**PARK CITY MUNICIPAL CORPORATION
PLANNING COMMISSION
CITY COUNCIL CHAMBERS
March 8, 2017**

Planning Commission Staff Report

Exhibit B – Sheet V-7 Parking and Emergency Vehicular Access

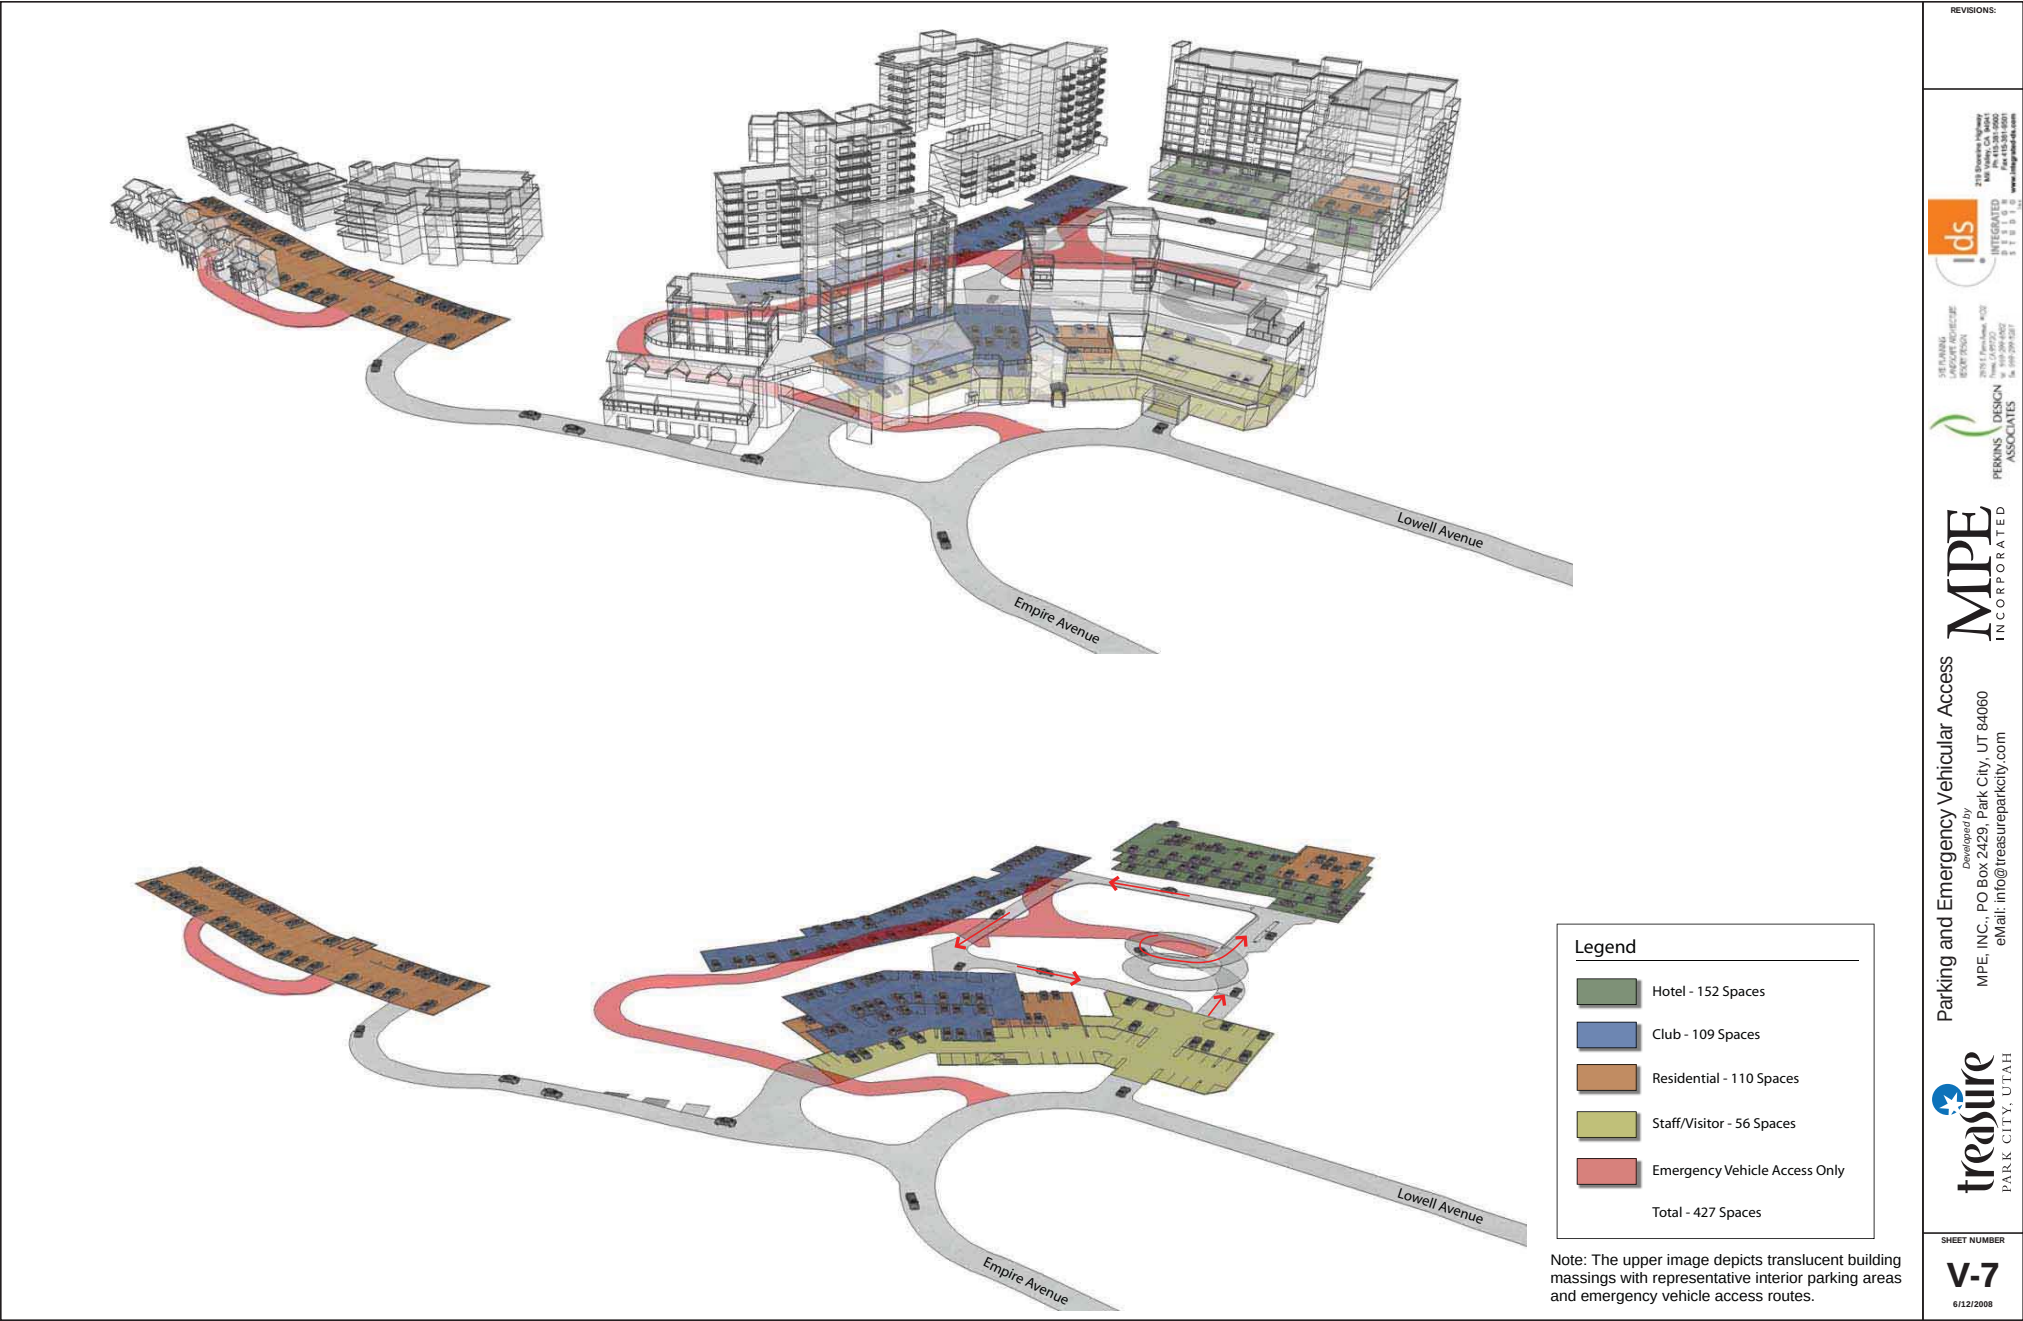
The set of plans updated in 2008 contain [Sheet V-7 Parking and Emergency Vehicular Access](#). Sheet V-7 indicates a total of 427 parking spaces being proposed and separates the parking spaces into four (4) areas: Hotel – 152 spaces, Club – 109 spaces, residential -110 spaces, and staff/visitor – 56 spaces. This sheet does not further clarify management or compliance with not drawing people from outside the development. Furthermore, this sheet assigns visitor parking. Staff would like to further understand how parking is to be managed.
